Change Order

RHS Culinary Arts Renovation BG 25-203
1103 W 9th Street
Russellville, KY 42276

Change Order Number: 001
Date: the 17th day of June in the year
2025

Re: PR-01– Electrical Panelboards
Russellville Independent Schools Culinary Arts Renovation
CMTA Project No. XRIH24

E4.0

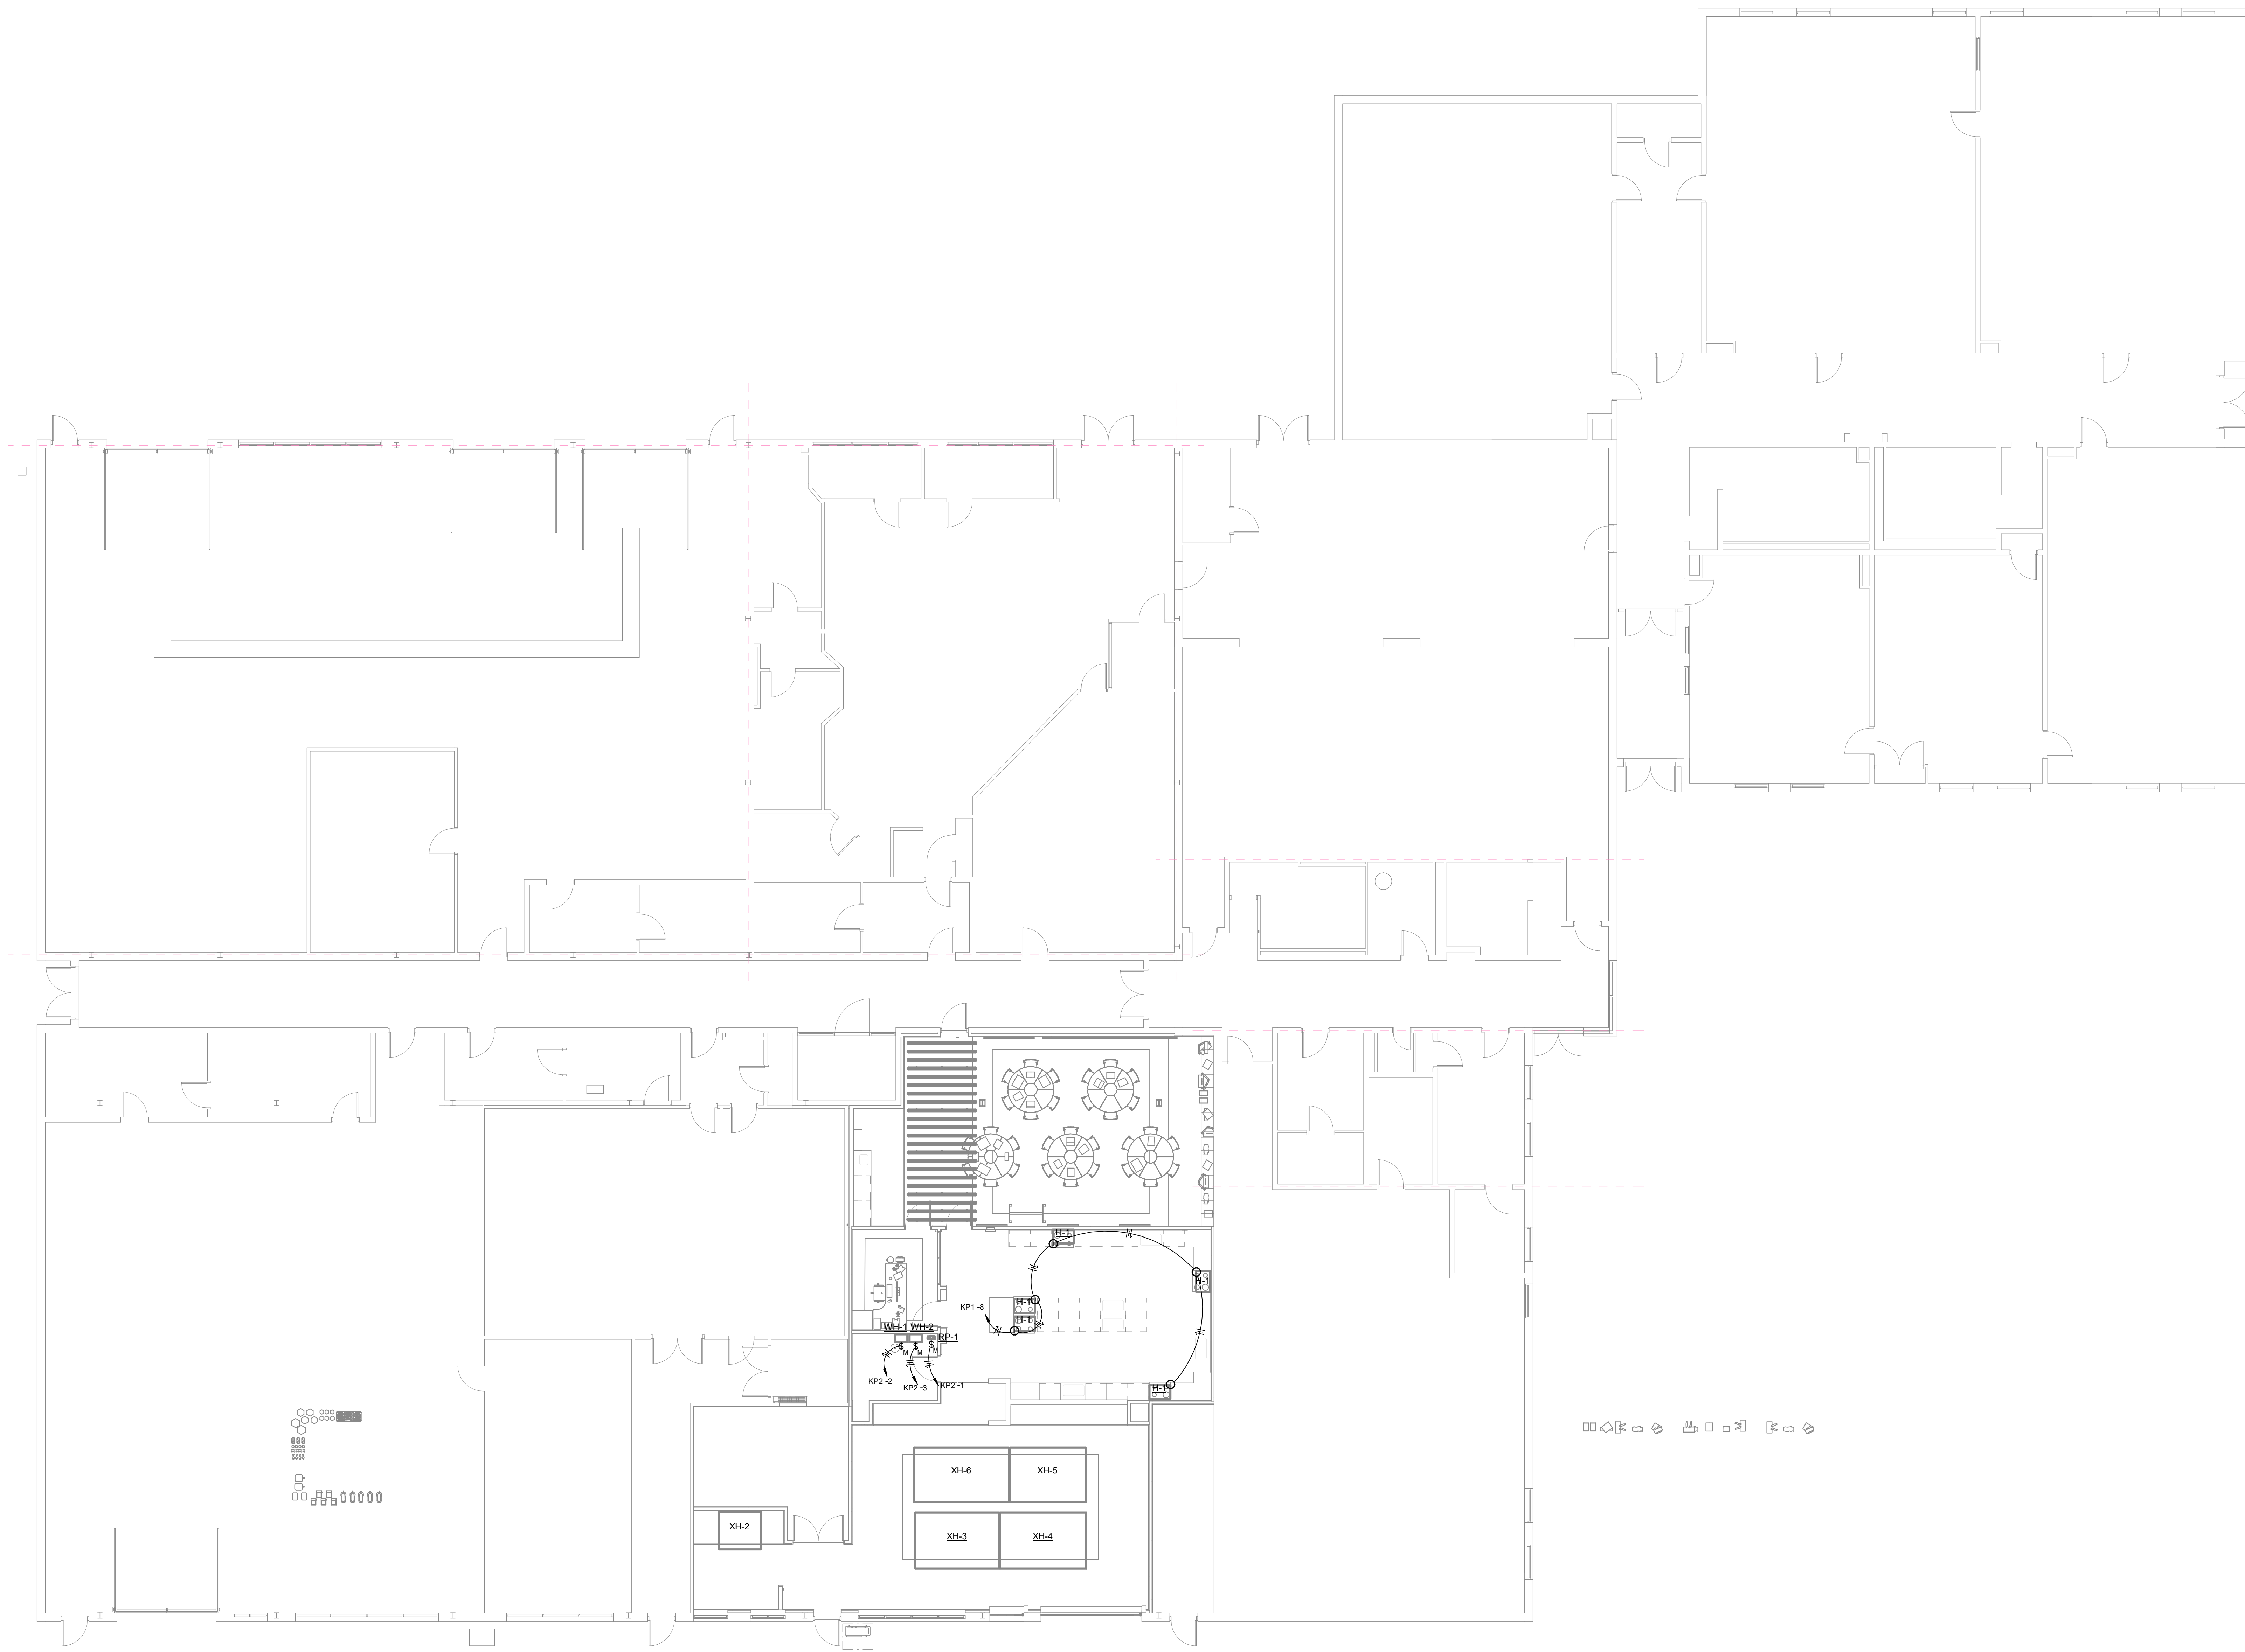
3. Refer to Sheet E4.0 – MECHANICAL POWER – NEW WORK – OVERALL PLAN
 - a. General: Refer to homerun arrows and updated panel-circuit number for each circuit. This issuance shall be used for panel numbering.

E4.1

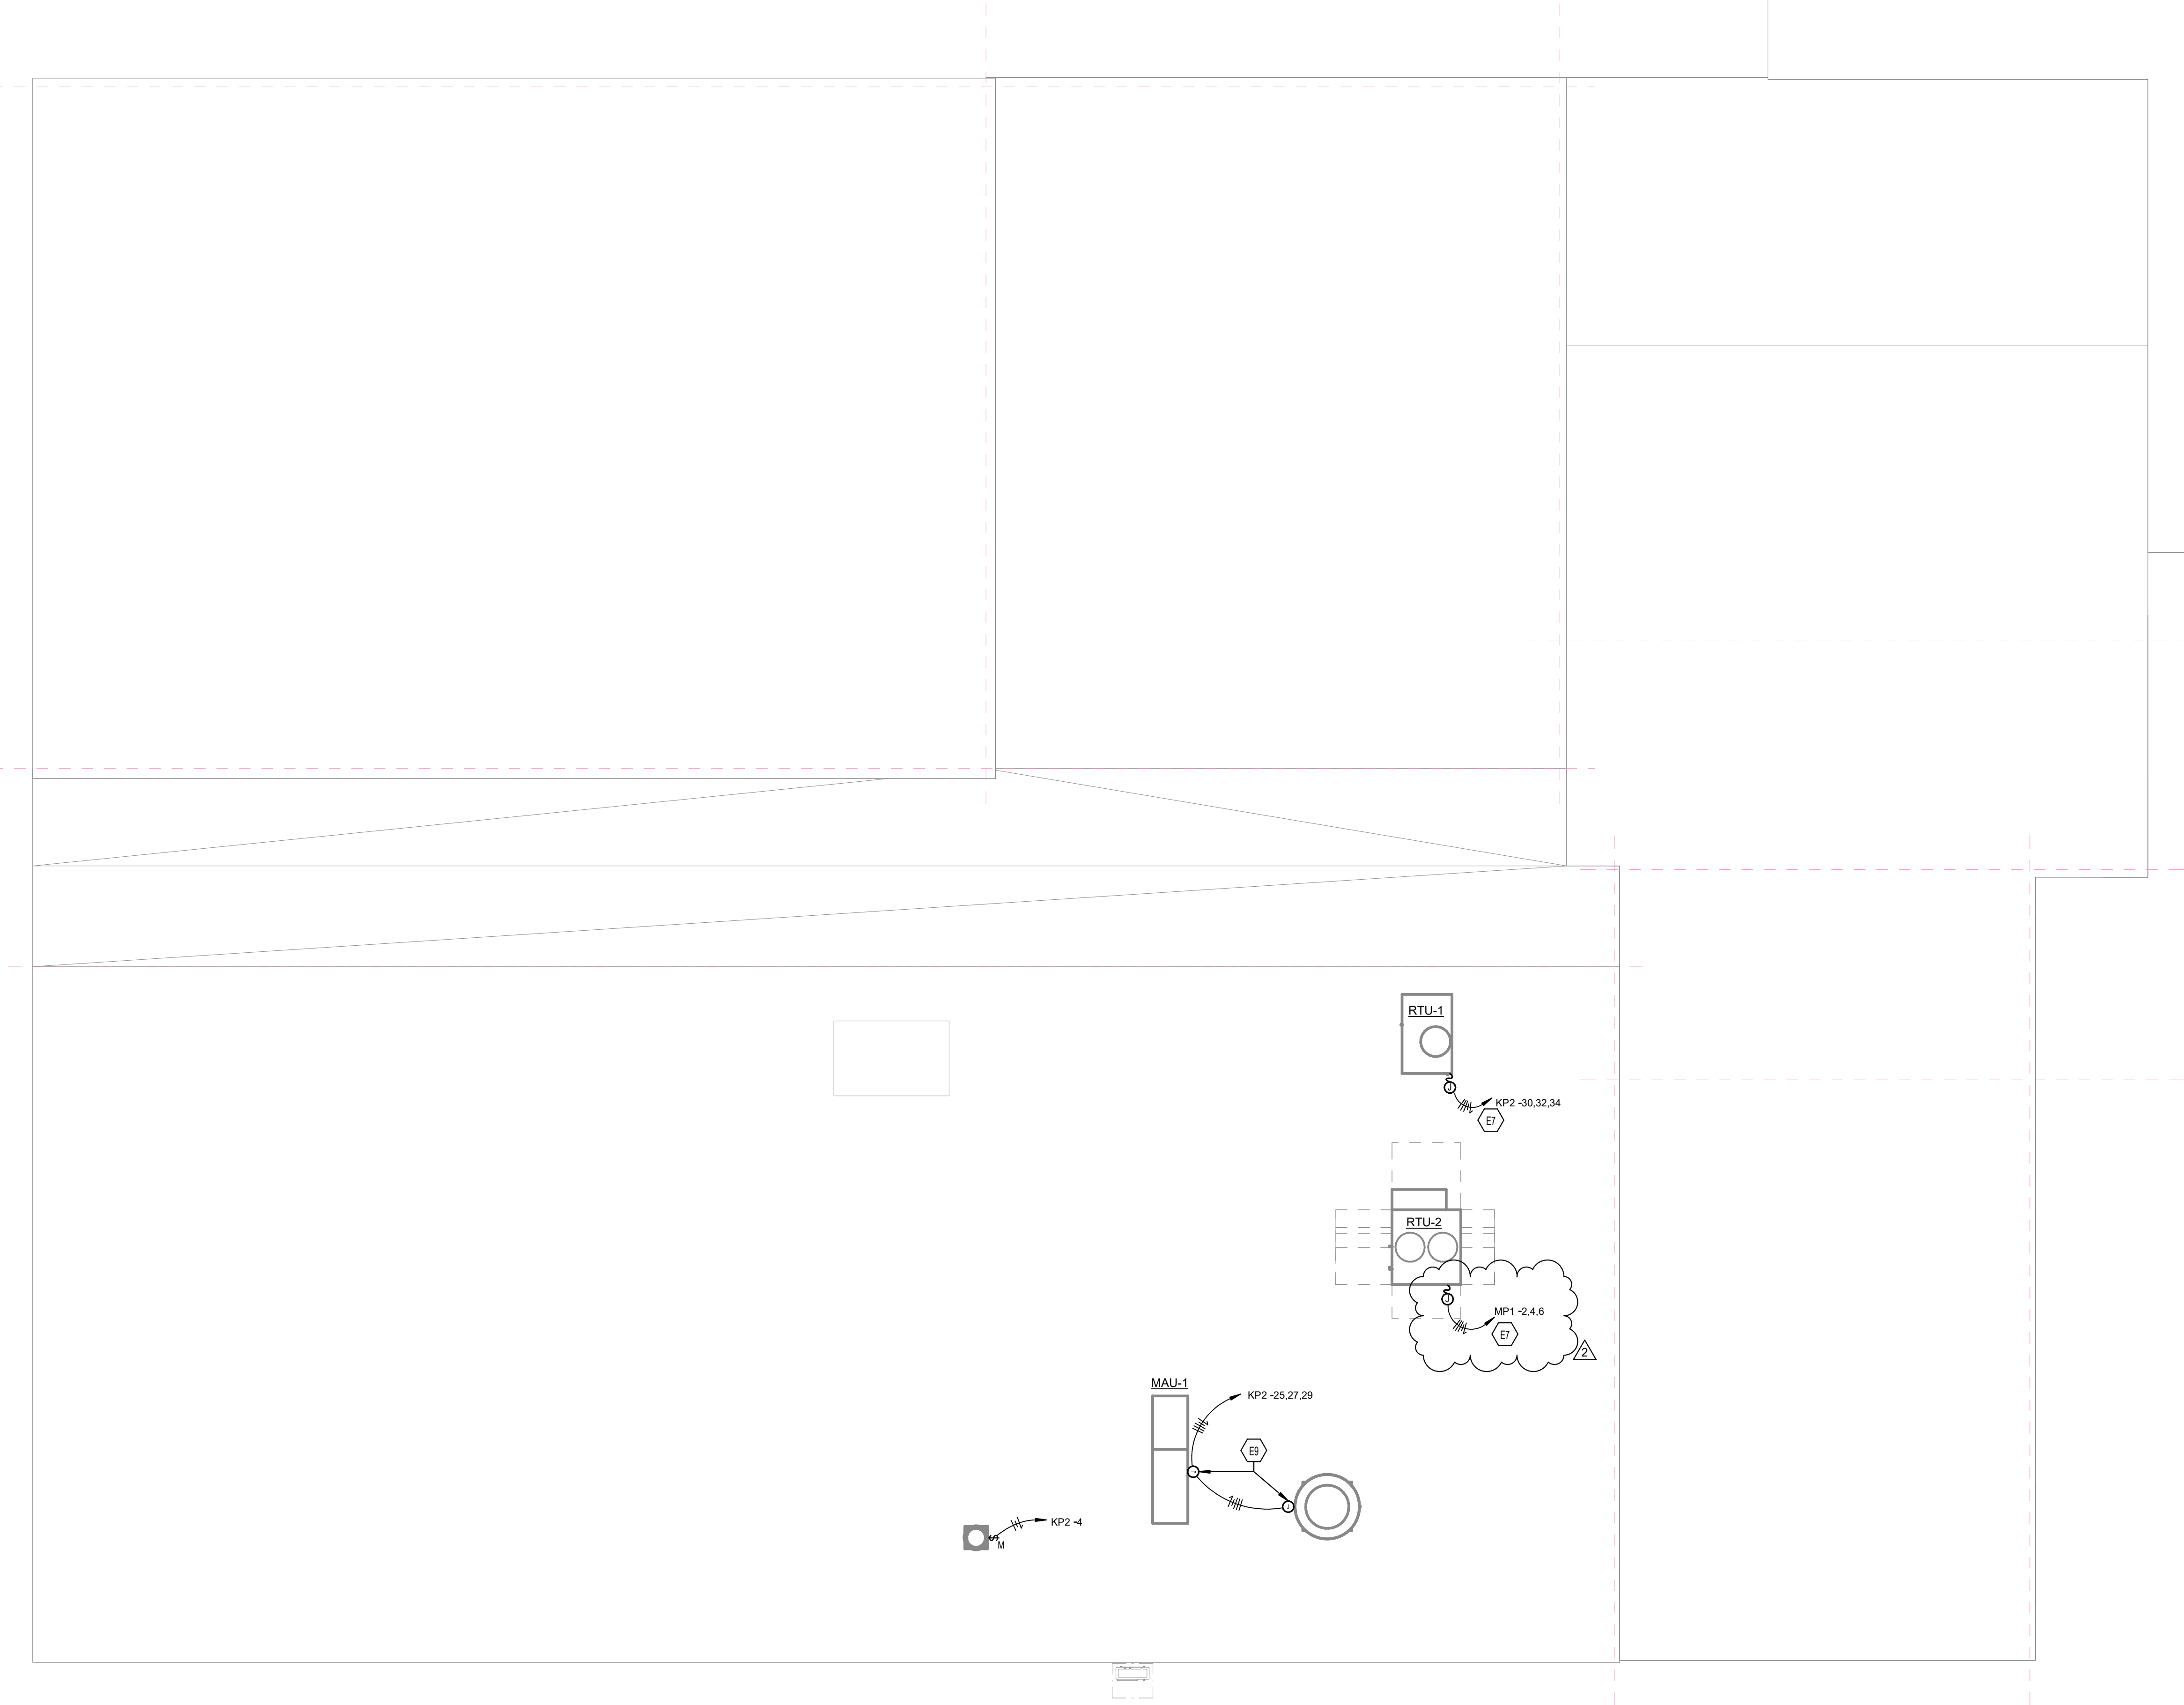
4. Refer to Sheet E4.1 – MECHANICAL POWER – NEW WORK – ROOF PLAN
 - a. General: Refer to homerun arrows and updated panel-circuit number for each circuit. This issuance shall be used for panel numbering.
